SERVICE BULLETIN

NON MODIFICATION SERVICE BULLETIN — ENGINE — NO. 4 BEARING, COOLING AIR DUCT, REAR — INSPECT AND REPLACE IF SUSPECT DUCTS ARE FOUND

V2500 Series 72-0640

V2500-ENG-72-0640

LOCATION OF NO. 4 BEARING COMPARTMENT AND MARKING LOCATION
FIGURE 1, SHEET 1

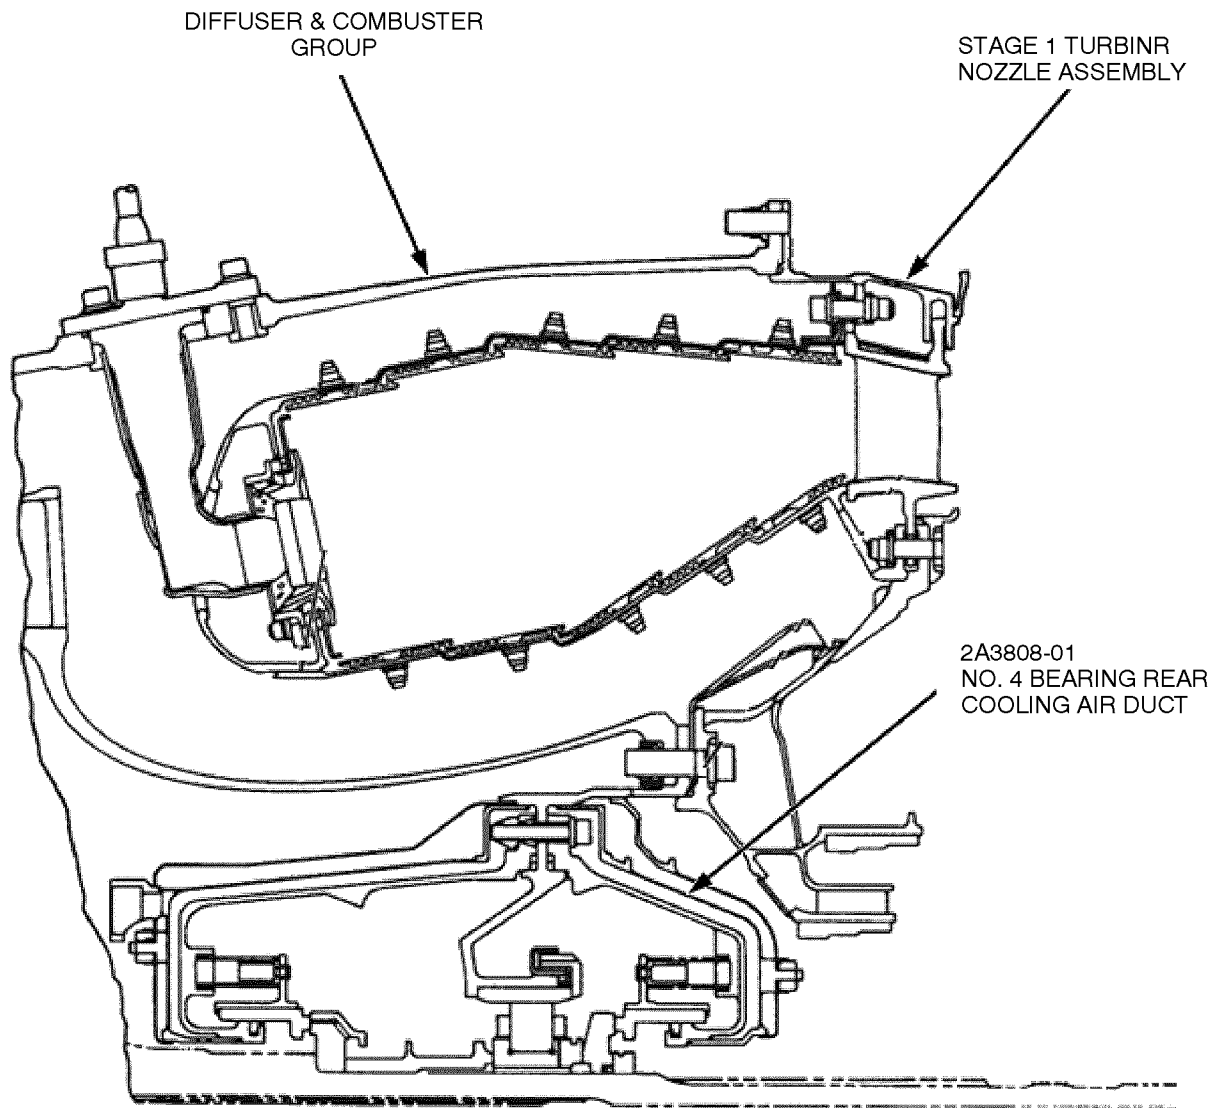
1. Remove the No. 4 Bearing Rear Cooling Air Duct, PN 2A3808-01 from the No. 4 Bearing and Rear Compartment. Refer to Reference 6, Engine Manual Task 72-00-43-020-001. See Figure 1 (Sheets 1 and 2).

LOCATION OF NO. 4 BEARING COMPARTMENT AND MARKING LOCATION
FIGURE 1, SHEET 2

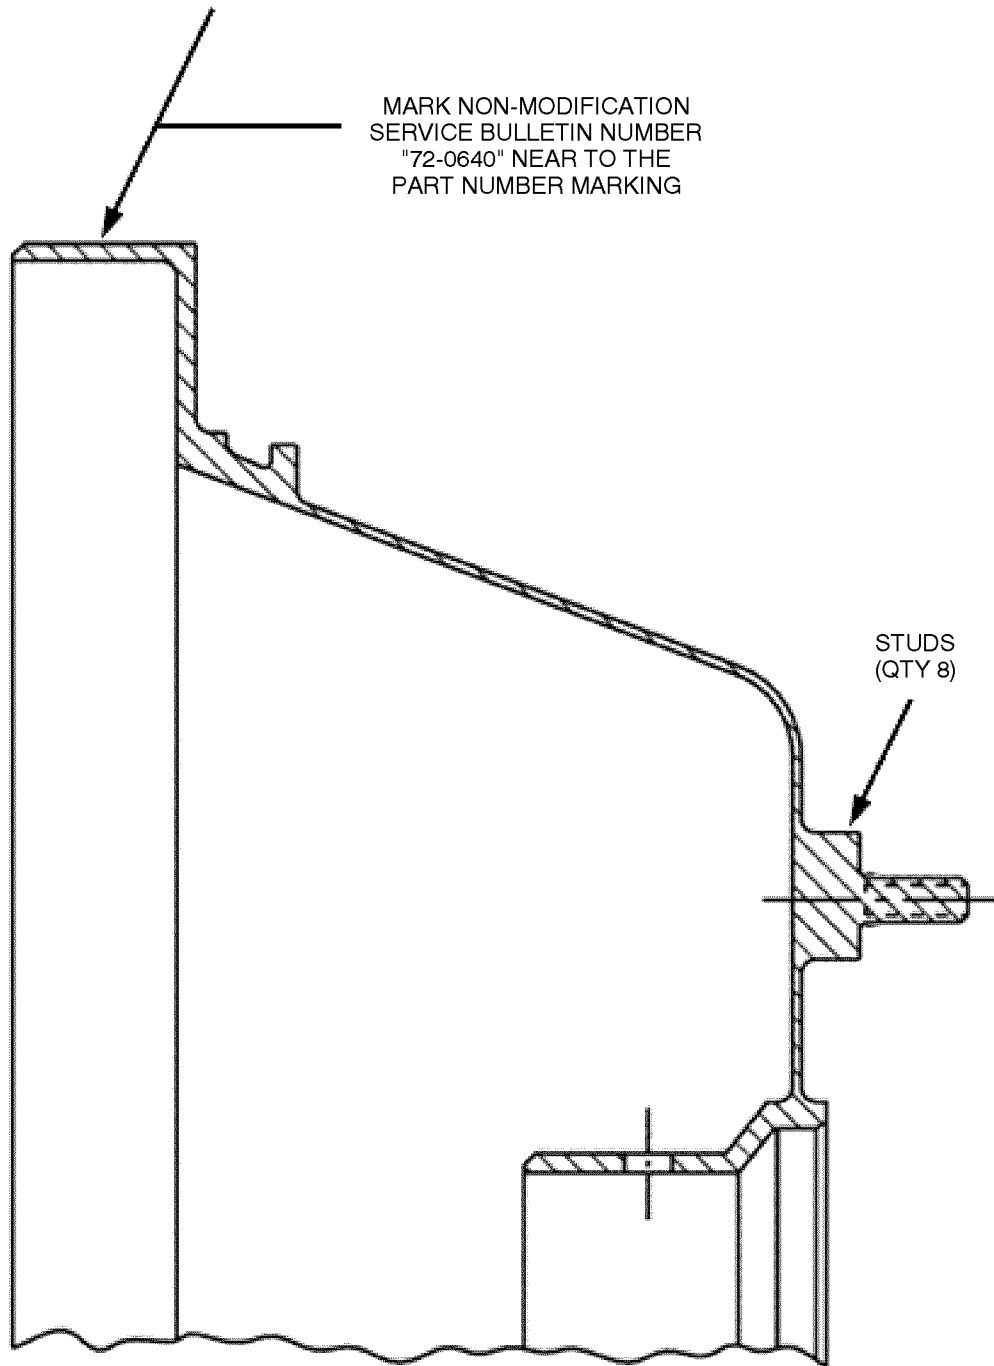
- A. Locate the lot number on the No. 4 Bearing Rear Cooling Air Duct marked adjacent to the part number. See Figure 1 (Sheet 2) for location of the lot number.

- B. If the lot number marked is 405215-0, 405604-0 or 408310-0, remove the part from service and return to the Vendor listed in Vendor Services or Special Components/Materials Section. Obtain a conforming No. 4 Bearing Rear Cooling Air Duct, PN 2A3808-01.

- C. Mark the conforming part (or) re-installed part at the location shown in Figure 1, Sheet 2 with this Non-Modification Service Bulletin number as "72-0640". See Reference 3, Standard Practices Manual, Chapter/Section 70-09-00, Marking of Parts. Approved marking methods are deep electrolytic etch, vibropeen, engrave (manual or mechanical), drag impression or deep dot peen.

LOT NUMBER MARKED HERE
(ADJACENT TO PART NUMBER MARKING)

MARK NON-MODIFICATION
SERVICE BULLETIN NUMBER
"72-0640" NEAR TO THE
PART NUMBER MARKING
